From: Amanda Scholes
Sent: 05 December 2019 09:56
To: Rebecca Payne
Subject: FW: A/100/19/PL - Arundel Acre - response to Highways England
Attachments: 20191204 HEPR re A_100_19_PL Arundel Acre.pdf; JNY10317-02 Tracking diagram Revised Access Location.pdf

Council's Reference: A/100/19/PL

Location: Arundel Acre, Arundel Road, Angmering.

Proposal: Change of use of land from agriculture for 3 No. travelling showpeople plots (Sui Generis) with associated storage barn, maintenance area, landscaping & infrastructure.

Title REVISED ACCESS LOCATION
SWEEP PATH ANALYSIS

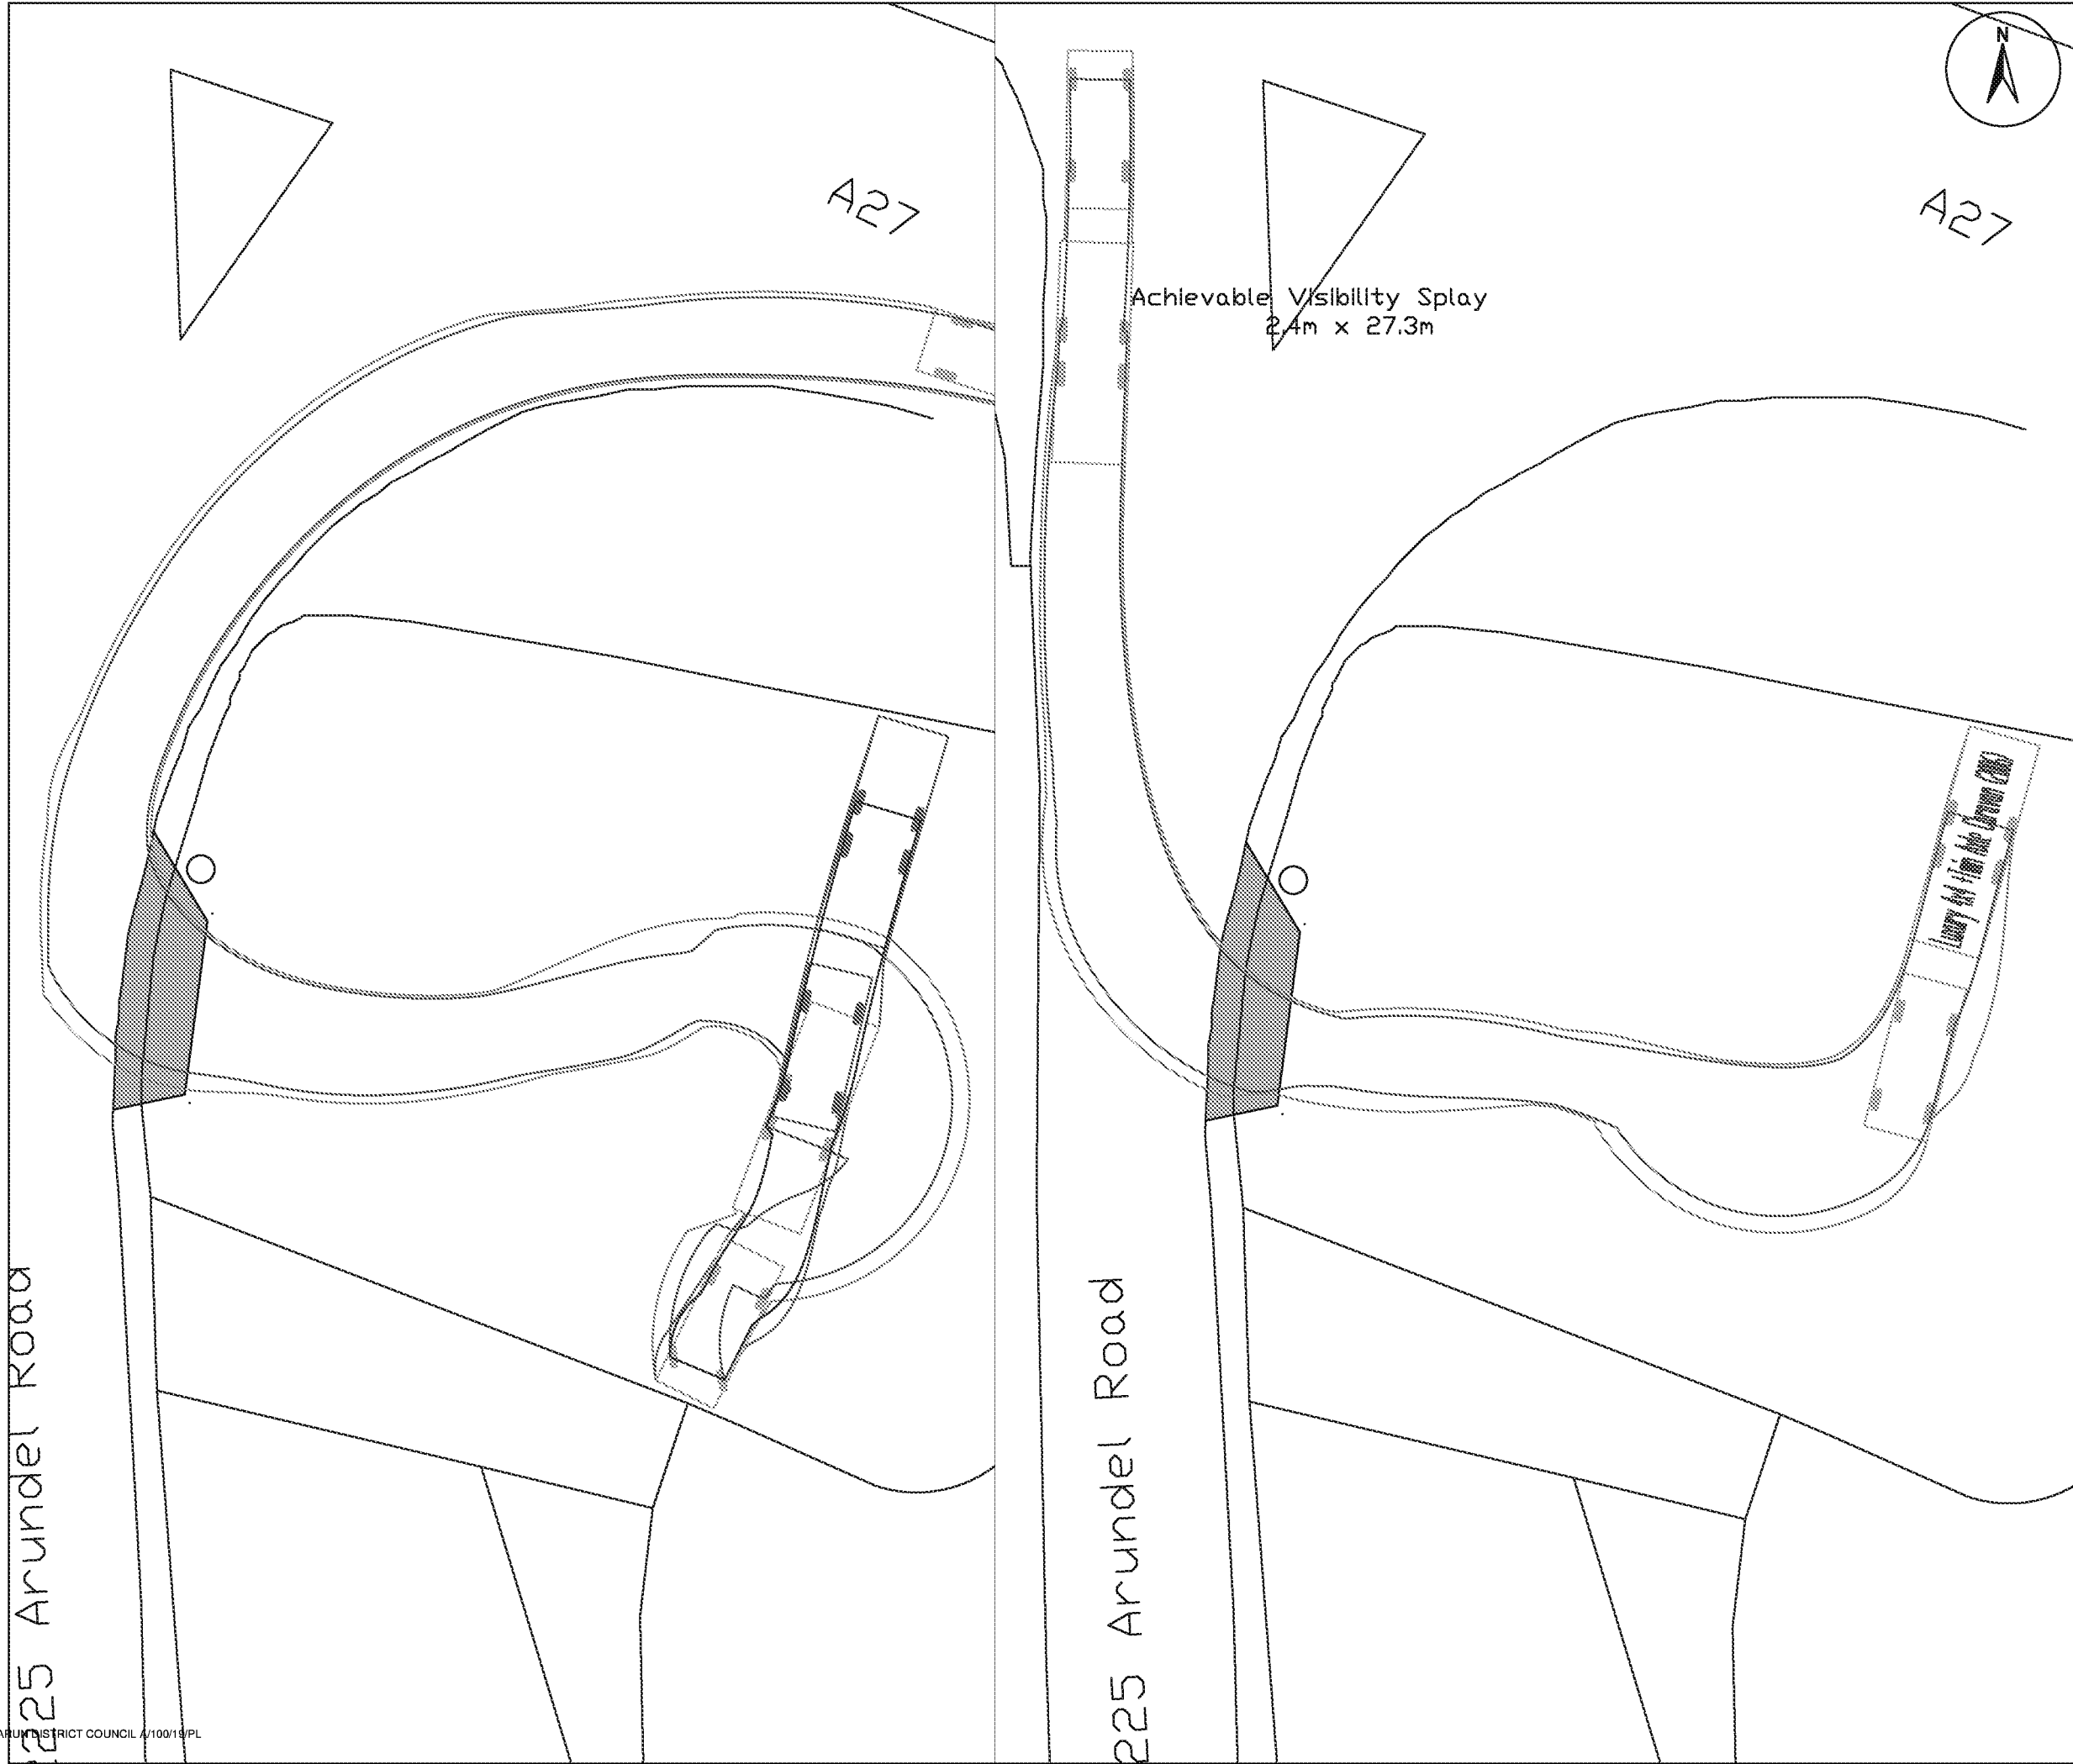
shortened and is not equivalent. The revised access is now on the apex of the bend's radius with associated limited visibility for vehicles manoeuvring in or out of the access.

We have been advised that no further information will be provided at this stage, and therefore, based on the information provided, Highways England will require conditions to be placed on any permission that require a further plan to be provided that shows the visibility splay all the way around the bend (not just from the site access), in order that a Safe Stopping Distance can be achieved around the corner in relation to any part of the vehicle and trailer shown in the swept path plan (Drawing No. JNY10317/02) manoeuvring into and out of the access. In this respect, please note that Manual for Streets is not appropriate for use associated with trunk roads or where speed limits are above 40mph. As such, the visibility splay will need to be provided in accordance with the results of the speed survey and DMRB calculations.

All vegetation within the visibility splay, including the oak tree, will need to be cleared and maintained in perpetuity so that the sightline can be achieved and maintained for the proposal to be acceptable. Such a plan will need to be provided to Arun District Council as the Local Planning Authority, who shall consult Highways England accordingly. As this is a retrospective application, the plan will need to be provided and agreed within 1 month of any permission, with the vegetation cleared before the bird breeding season and within 2 months of any permission.

We also attach an updated vehicle tracking diagram (Drawing No. JNY10317/02) demonstrating that vehicles will be capable of entering and leave the site on forward gear.

- 1) Within 1 month of permission being granted for the development, a further visibility splay plan will be provided to the Local Planning Authority (who shall consult Highways England) that shows the visibility splay all the way around the bend, and not just from the site access, in order that a Safe Stopping Distance can be achieved around the corner in relation any part of the vehicle and trailer shown in the swept path plan manoeuvring into and out of the access.

- 2) Before the bird breeding season and within 2 months of permission being granted for the development, all vegetation, including the oak tree, within the agreed visibility splay (as subject to condition 1) will be cleared, and the area of the visibility splay within the applicant's site boundary thereafter will be maintained in perpetuity so that the sightline associated with the visibility splay can be achieved and maintained.
